APPLICATION NO.	FILING DATE	FIRST NAMED INVENTOR	ATTORNEY DOCKET NO.	CONFIRMATION NO.
10/719,352	11/21/2003	John R. Wall	3257-031853	3304

Office Action Summary	Application No. 10/719,352	Applicant(s) WALL, JOHN R.	
	Examiner Daniel J. Mills	Art Unit 3679

DETAILED ACTION

Figure 1

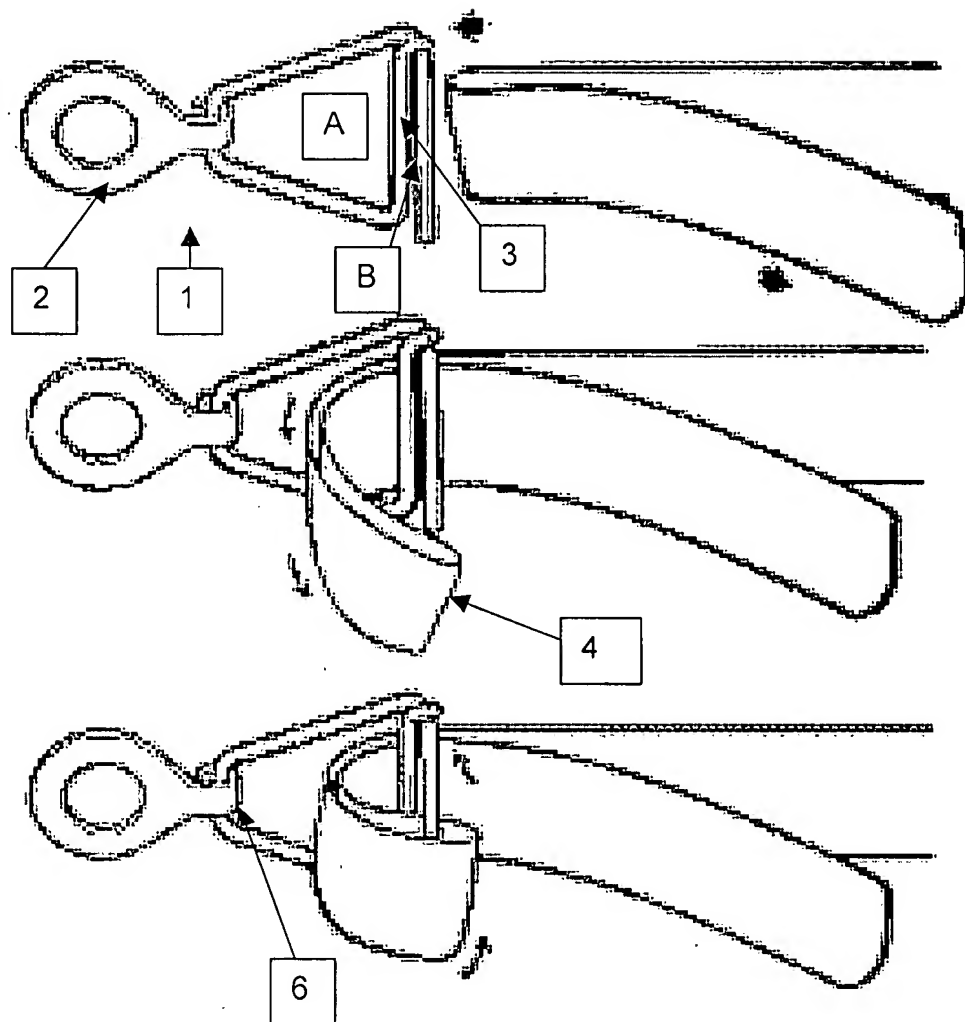
Regarding claim 1, Safe-Fence discloses a fence comprising a rail consisting of at least two metal wires ensheathed in a plastic web (the webbing used for the fence is

disclosed as having stainless steel wires interwoven), a slotted connector (1) having a face plate (encompasses the entirety of 1) with two slots (A and B) and a middle portion (3) separating the two slots, the connector having a front side (facing away from reader) and a rear side (facing toward reader) and also having a post attachment end (2), a free end of the rail (4) being disposed in the slotted connector so that the rail runs from the front side of the connector through a first slot (A) nearest the post attachment end, round the middle portion (3), and then back through the second slot (B), and a post (5) to which the slotted connector is attached using a fastener (5).

Regarding claim 3, Safe-Fence in view of Johnson and Robbins Jr. results in a fence wherein the end connector is attached to the post using a fastener (see figure 1) which permits the connector to pivot about the fastener.

Regarding claim 4, Safe-Fence in view of Johnson and Robbins Jr. results in a fence wherein the faceplate further comprises a through hole (see 2) adapted to receive the fastener.

Regarding claim 6, Safe-Fence in view of Johnson and Robbins Jr. results in a fence wherein the faceplate (encompasses the entirety of 1 includes a bend between the first slot and the post attachment end (2) (this is shown in figure 1 in the photo of the R-50 corner tensioner).

Regarding claim 1, Safe-Fence discloses a fence comprising a rail consisting of at least two metal wires ensheathed in a plastic web (the webbing used for the fence is disclosed as having stainless steel wires interwoven), a slotted connector (1) having a face plate (encompasses the entirety of 1) with two slots (A and B) and a middle portion (3) separating the two slots, the connector having a front side (facing away from reader) and a rear side (facing toward reader) and also having a post attachment end (2), a free end of the rail (4) being disposed in the slotted connector so that the rail runs from the front side of the connector through a first slot (A) nearest the post attachment end,

round the middle portion (3), and then back through the second slot (B), and a post (5) to which the slotted connector is attached using a fastener (5).

Regarding claim 2, Safe-Fence in view of Brattstrom and Robbins Jr. results in a fence wherein the end connector comprises return edges extending along opposing sides of the rigid member, the return edges extending perpendicularly from the faceplate (the hooks 6 shown on either side of component 2 on the R-50 corner tensioner, curve perpendicularly away from the plane of the faceplate).

Regarding claim 6, Safe-Fence in view of Brattstrom and Robbins Jr. results in a fence wherein the faceplate (encompasses the entirety of 1 includes a bend between the first slot and the post attachment end (2) (this is shown in figure 1 in the photo of the R-50 corner tensioner).
